Carlyle/Eisenhower East Design Review Board (DRB) Application

PROJECT NAME: Carlyle Block P BLOCK: P

DESCRIBE THE REQUEST BRIEFLY: Approval to minor modifications to the previously approved design of the South Tower of Carlyle Block P.

765 JOHN CARLYLE - SOUTH TOWER

2 WINDOW CHANGES

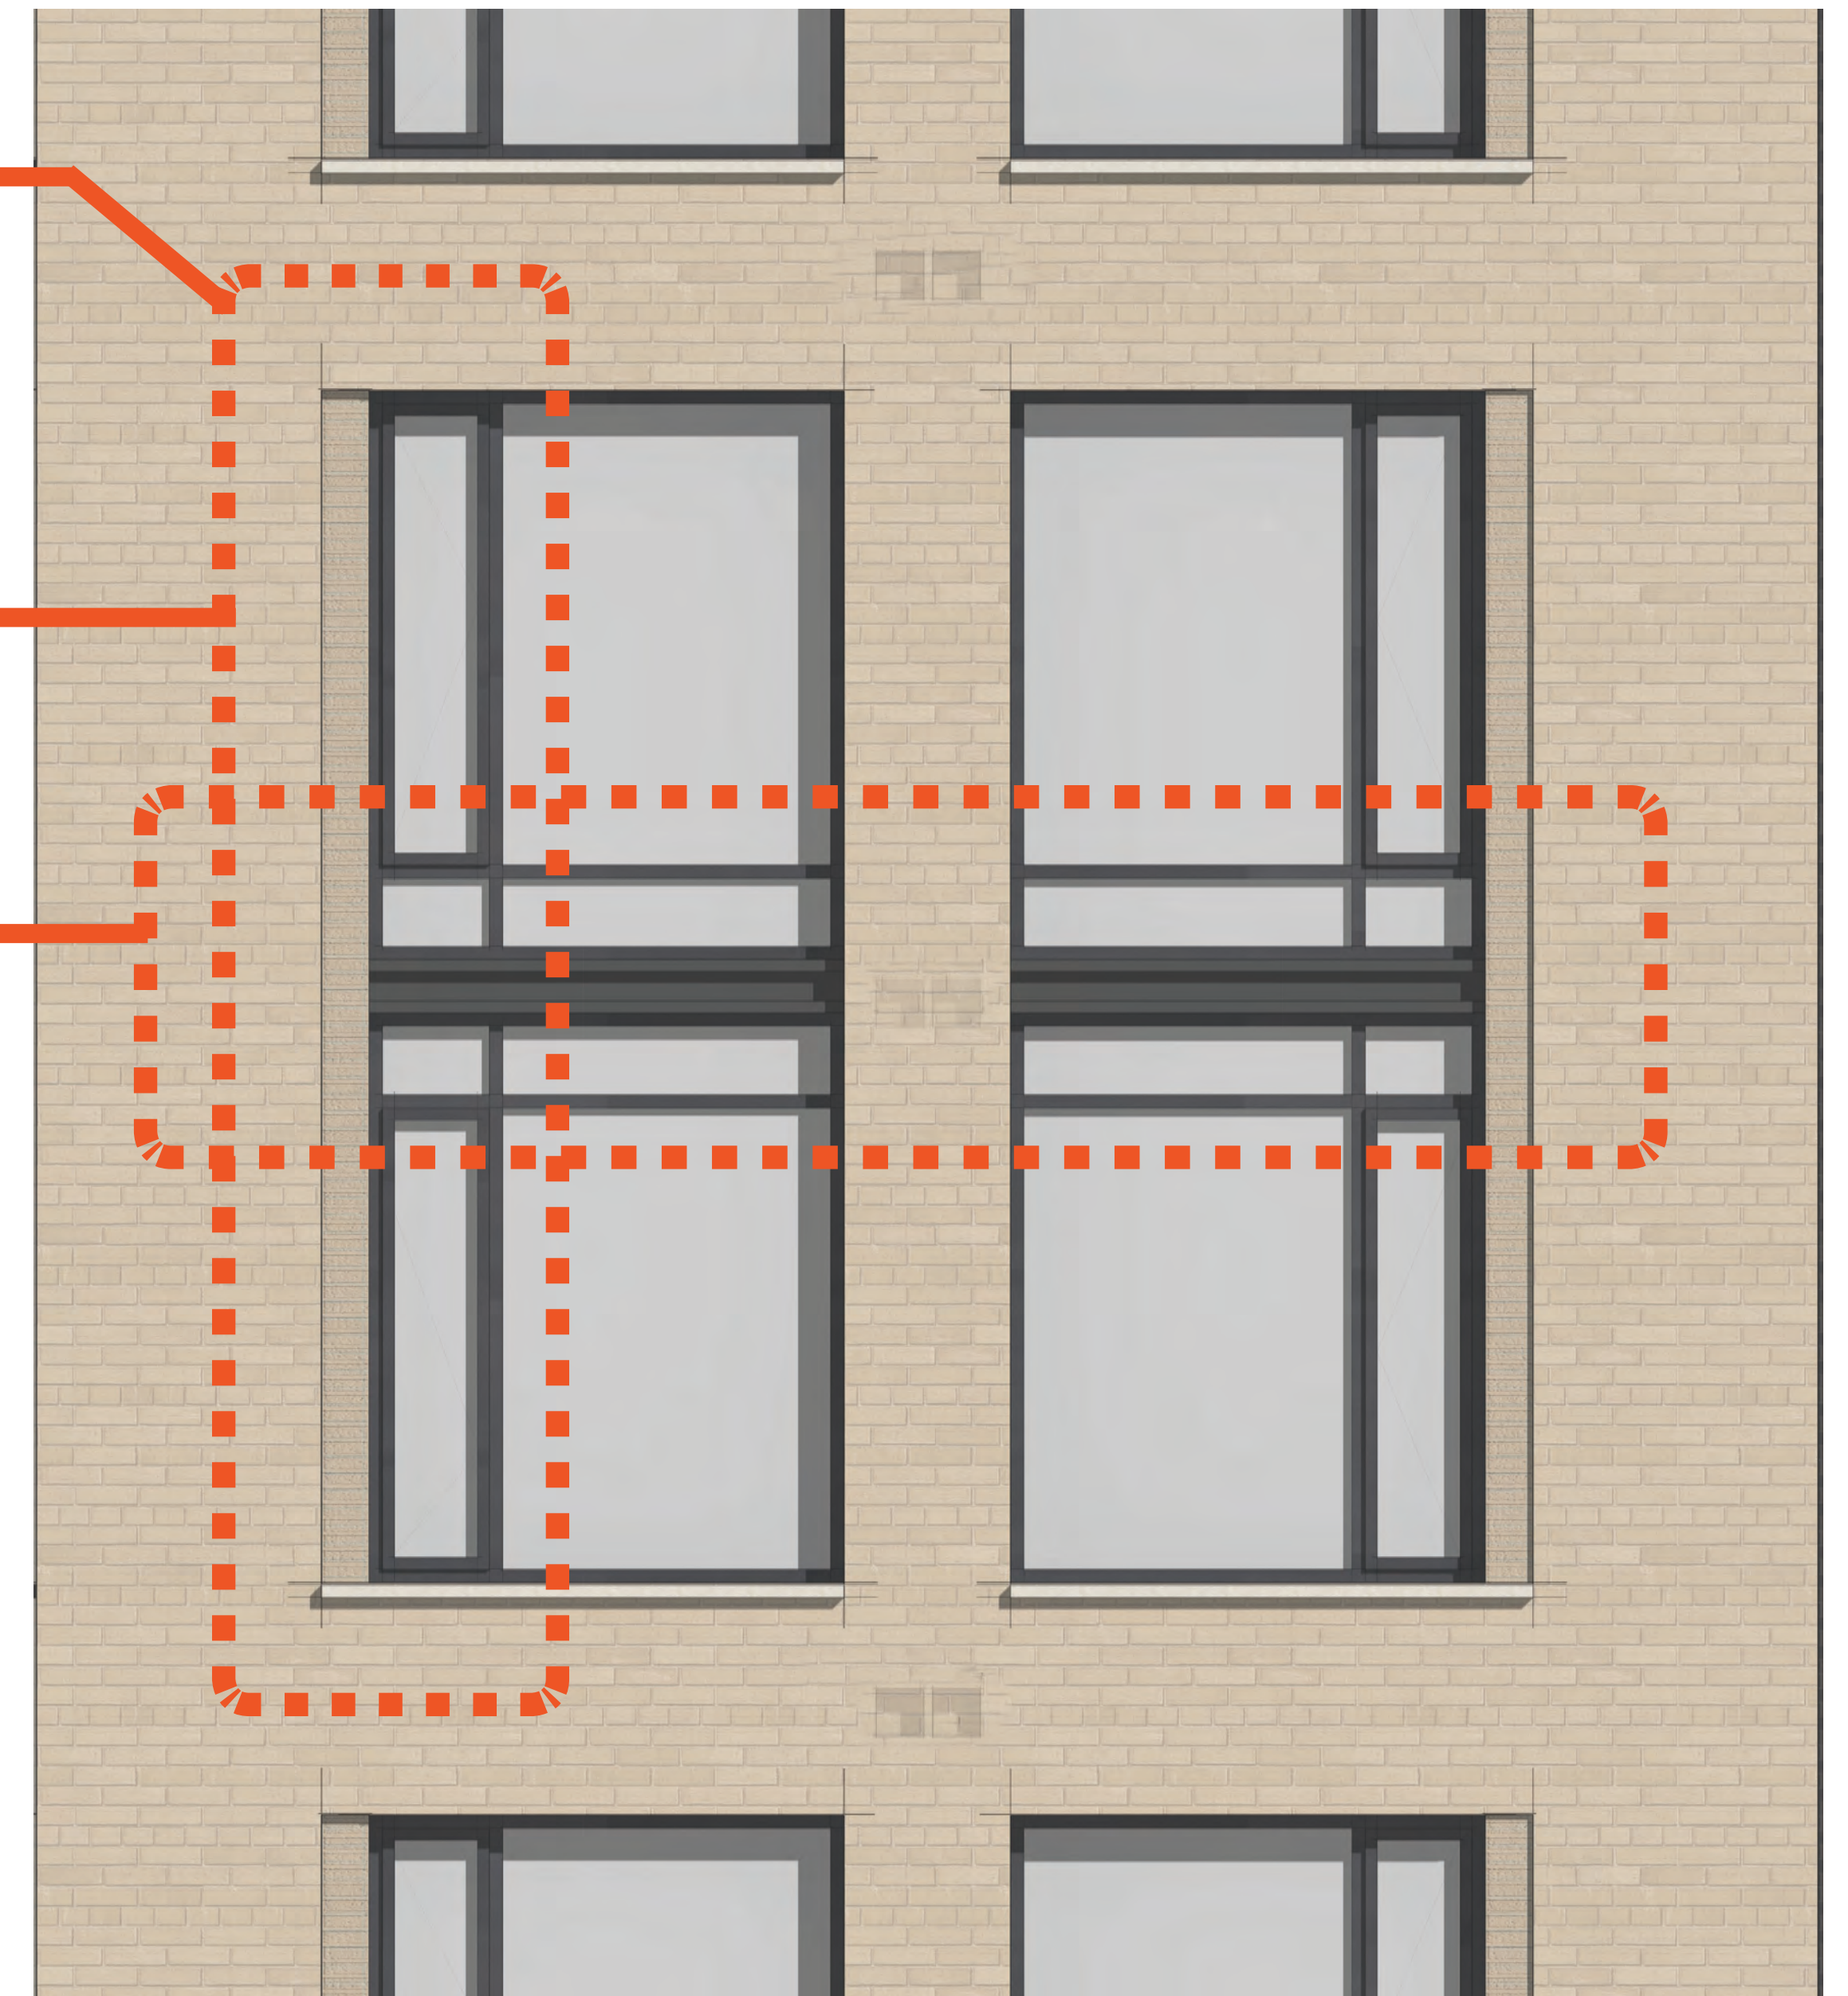
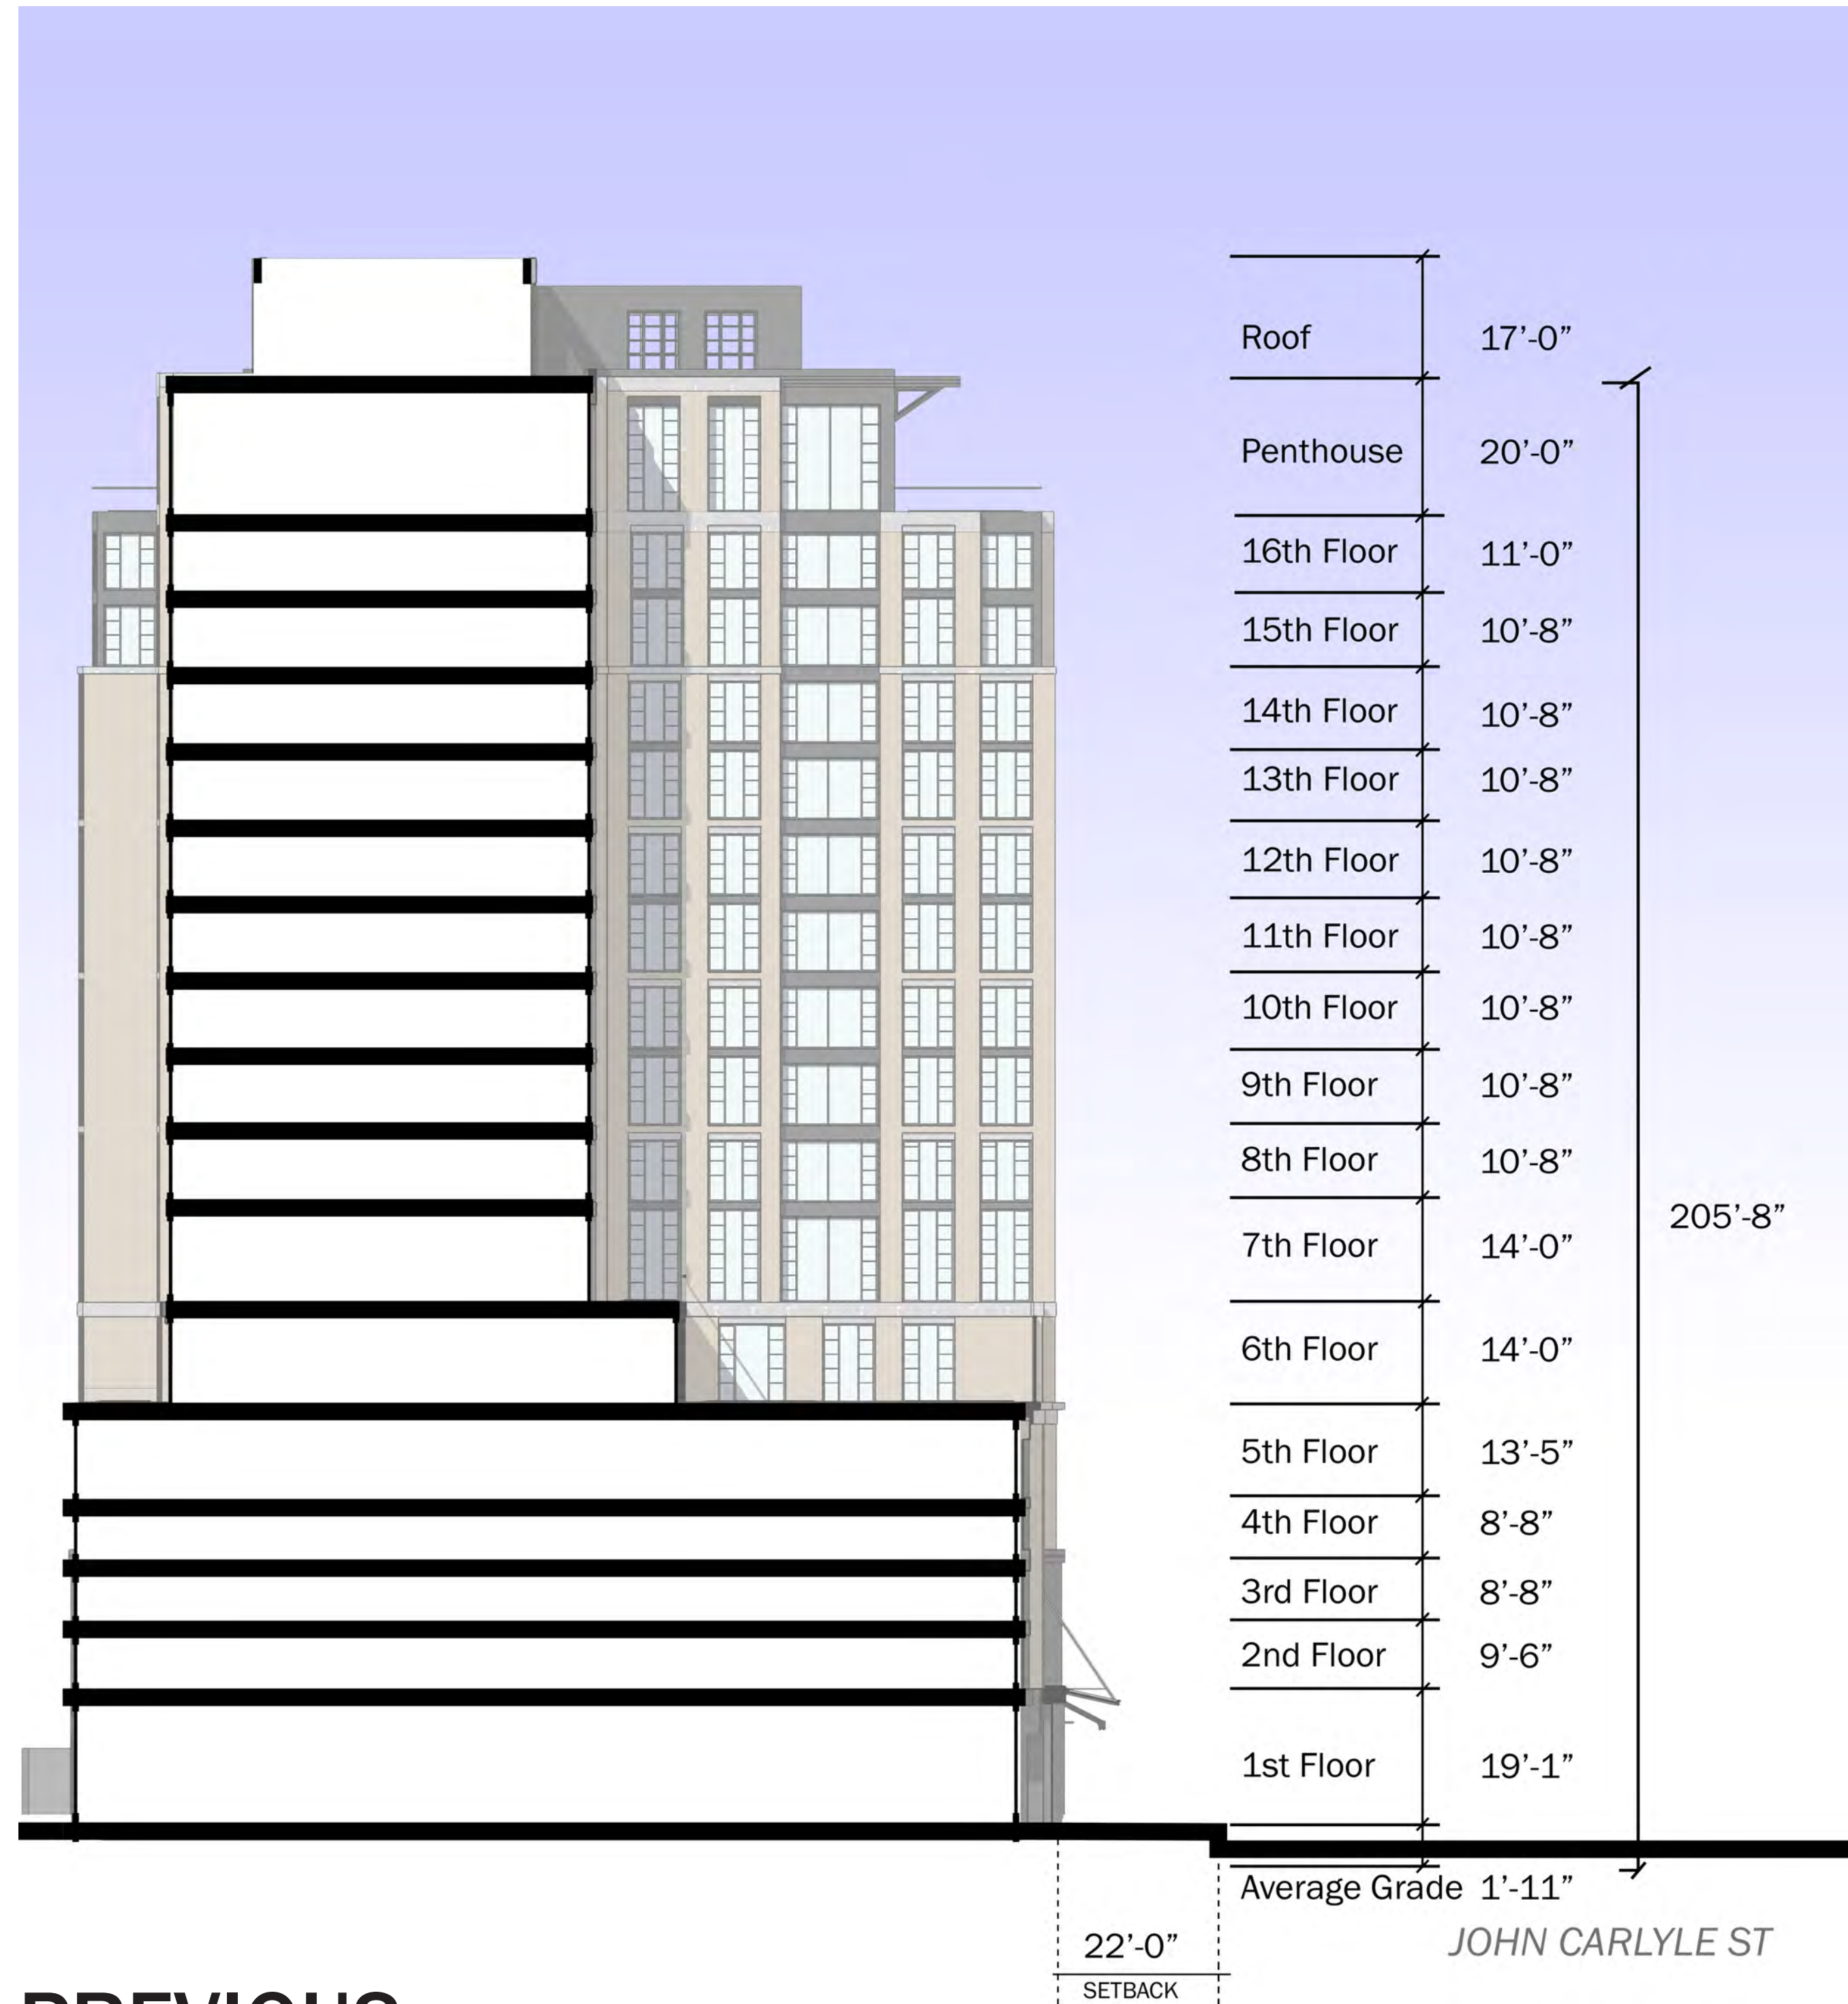
RECESSED SOLDIER COURSE BRICK ON SIDE IN LIEU OF WINDOW HEADER

MULTI-PANE WINDOW BECOMES FOUR PANES WITH OPERABLE PANE

WINDOWS REMAIN PAIRED WITH DARK METAL SLAB COVERS BETWEEN WINDOWS

3 FLOOR TO FLOOR HEIGHT COMPARISON

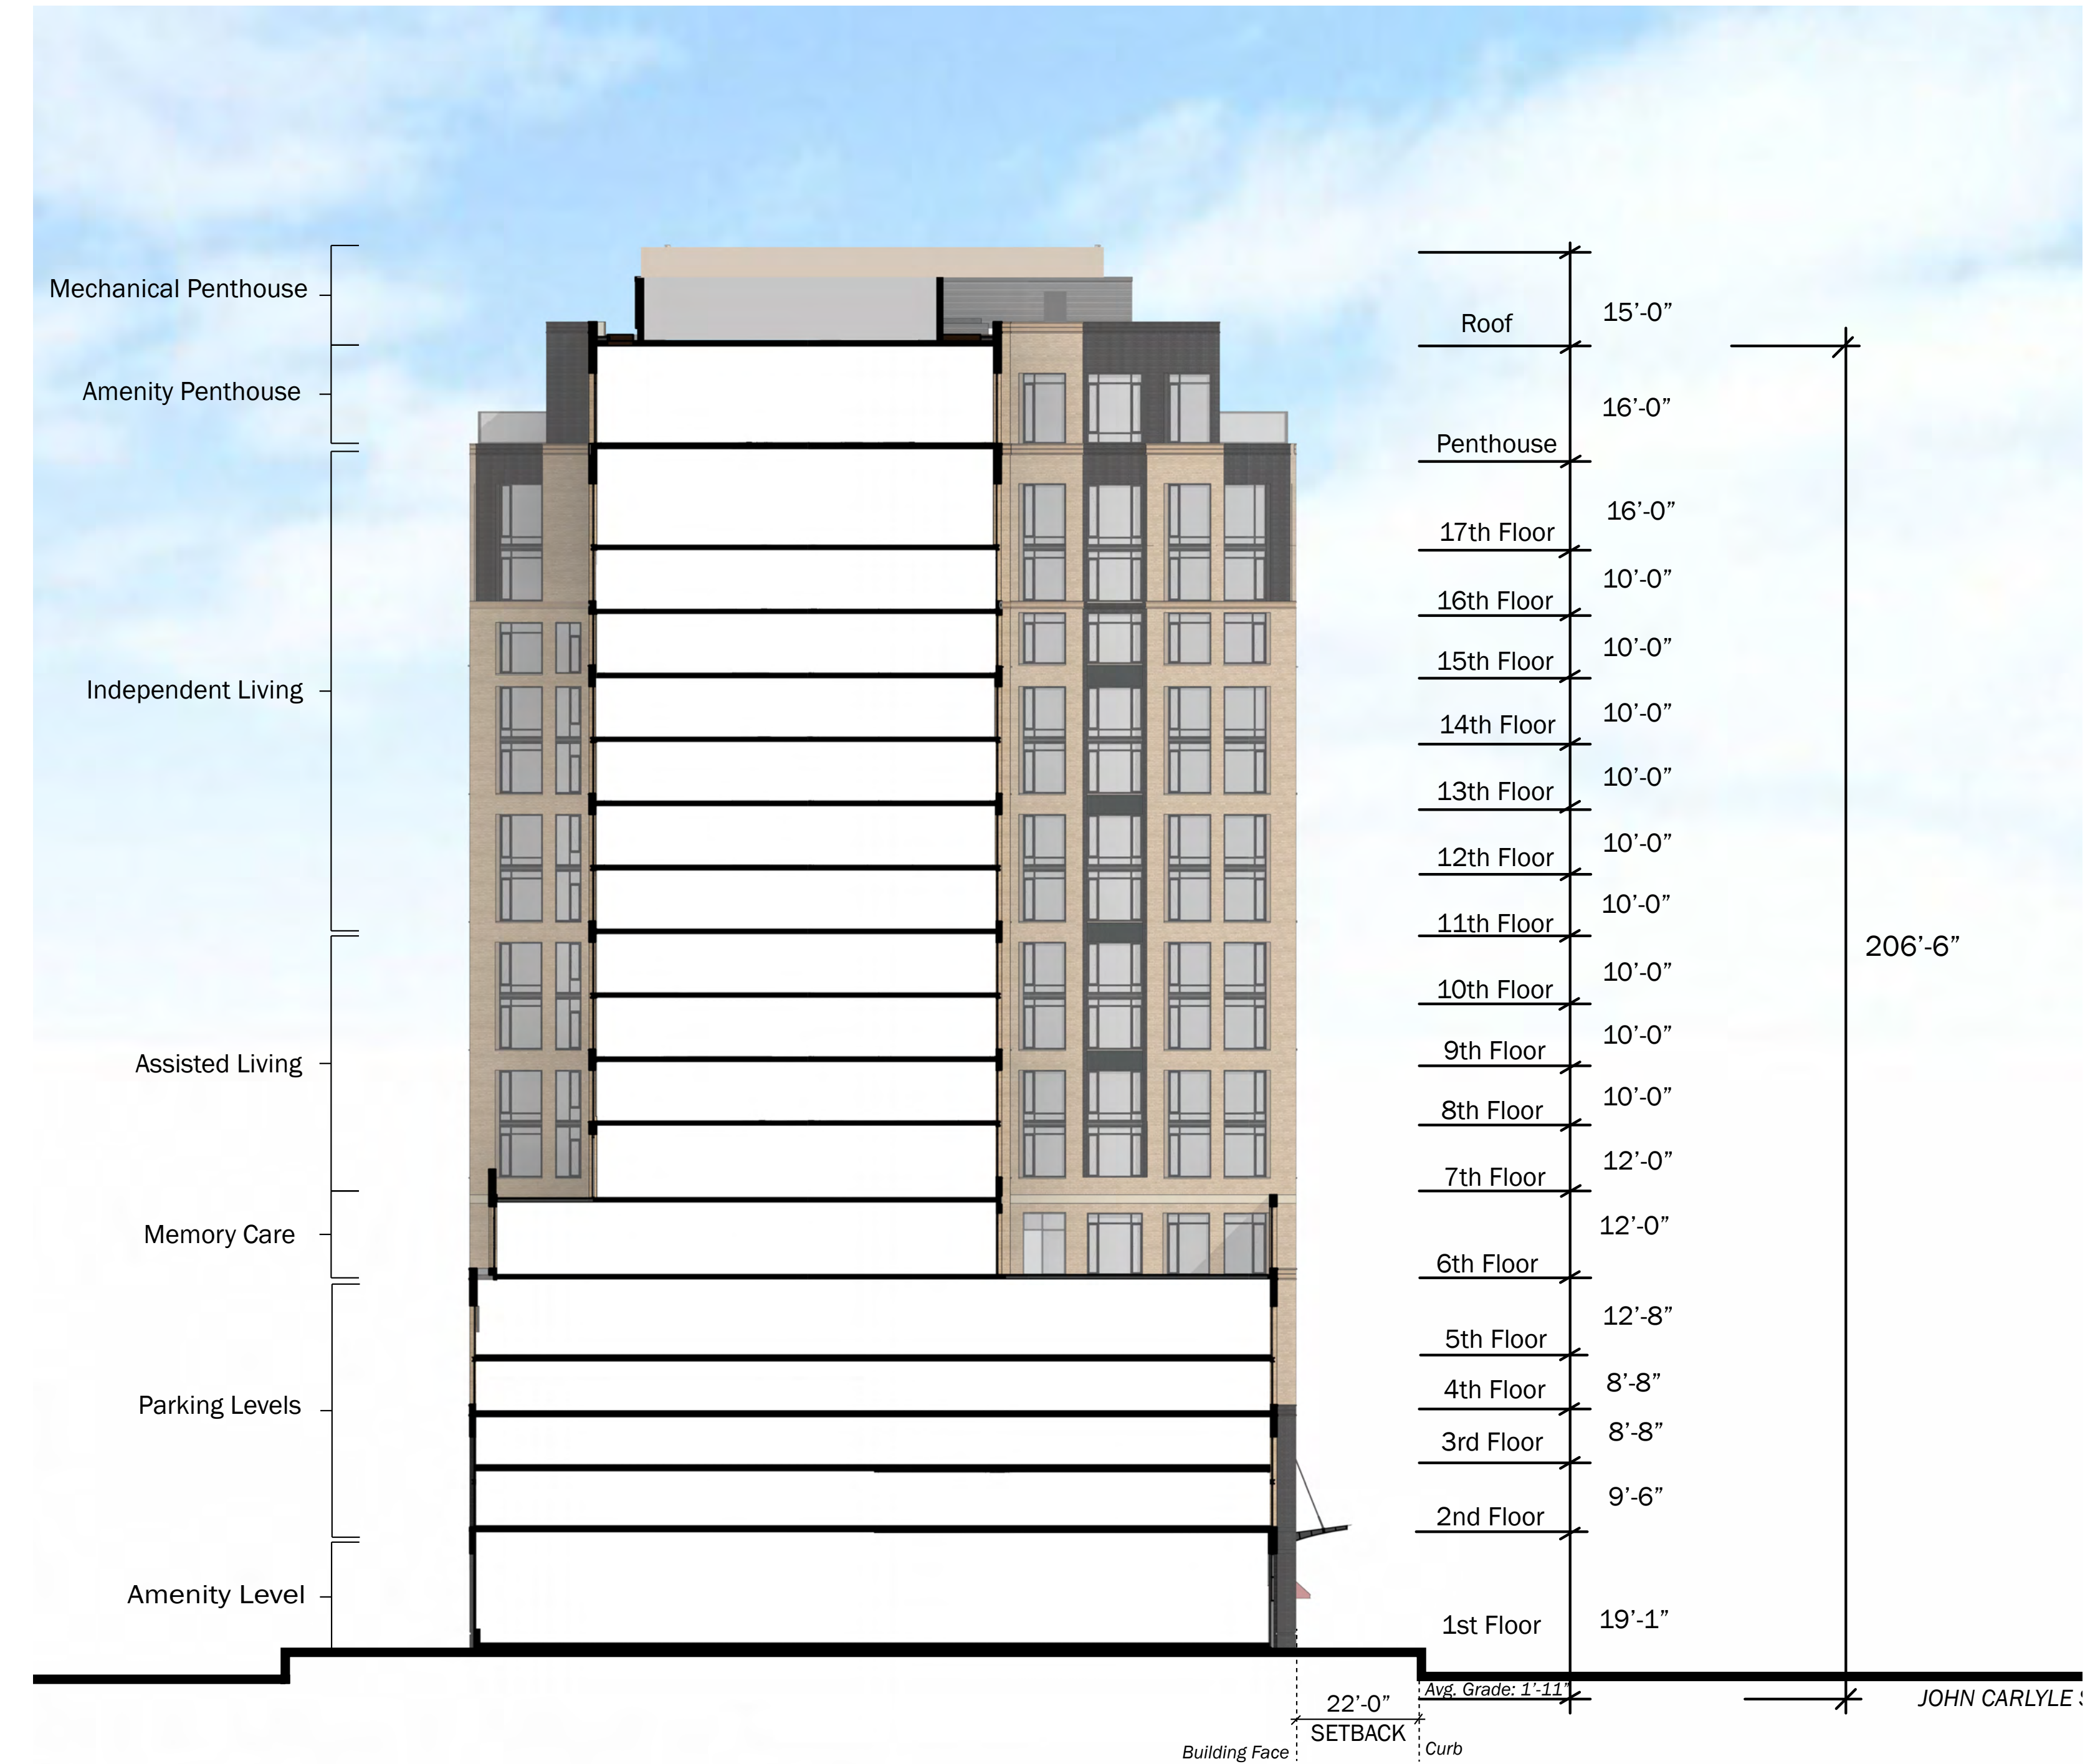
WINDOW PATTERN
REVISED AT FLOOR 15
FOR ADDED FLOOR
